Summary of Agency and Tribal Feedback for Jeffers Petroglyphs Site and Red Rock Ridge

Big Bend Wind Project – Summary of Feedback

This is a living document which is updated frequently to provide additional detail and recent feedback. This version is current as of September 29th, 2020.

Incorporating Feedback: Revising Project Boundary

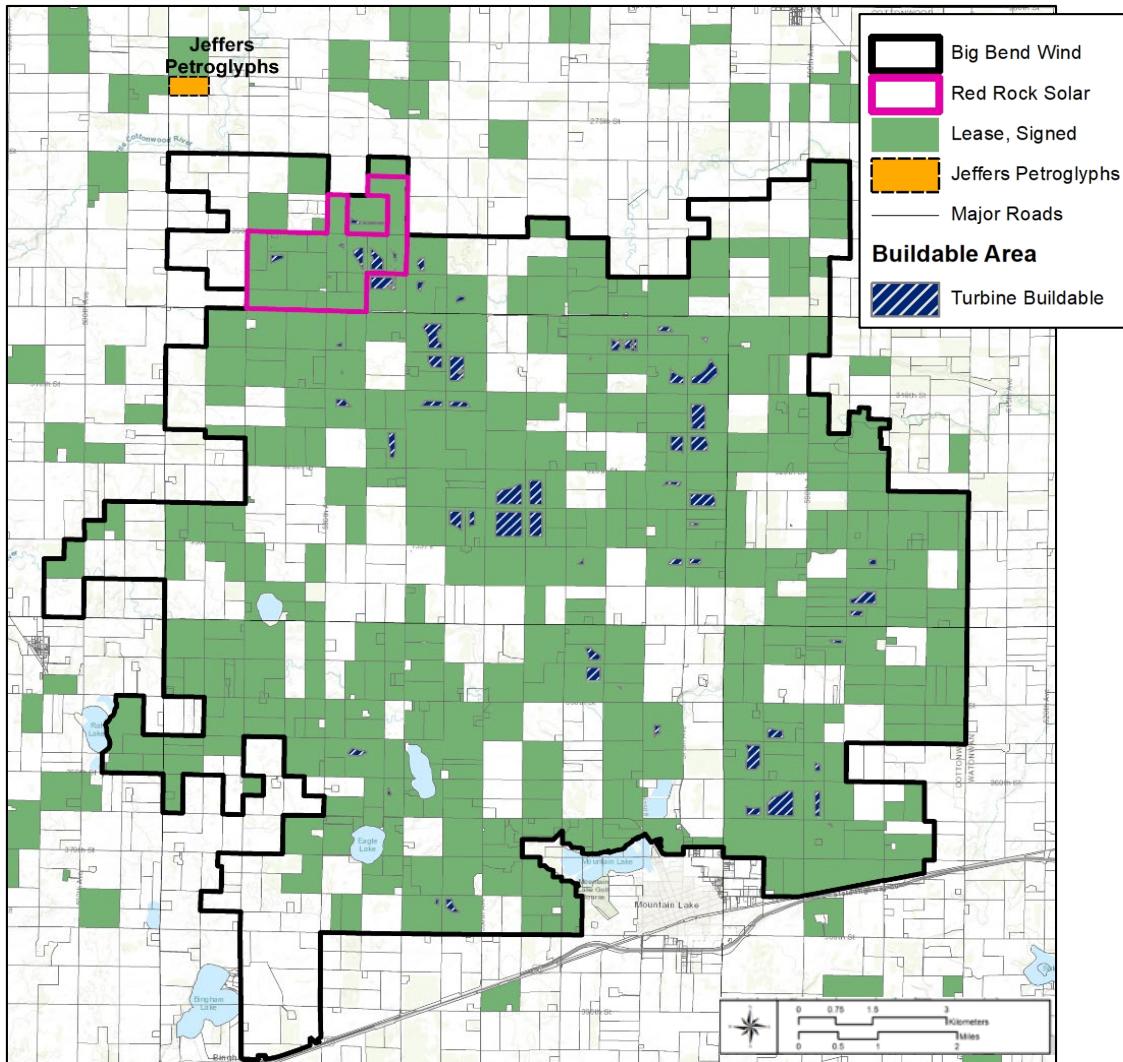
- Boundary has been revised to avoid Jeffers Petroglyphs
- Current project area is >0.5 miles from Jeffers Petroglyph site
- As currently planned, the nearest turbine will be 2.3 mi from SE corner of Jeffers Petroglyphs
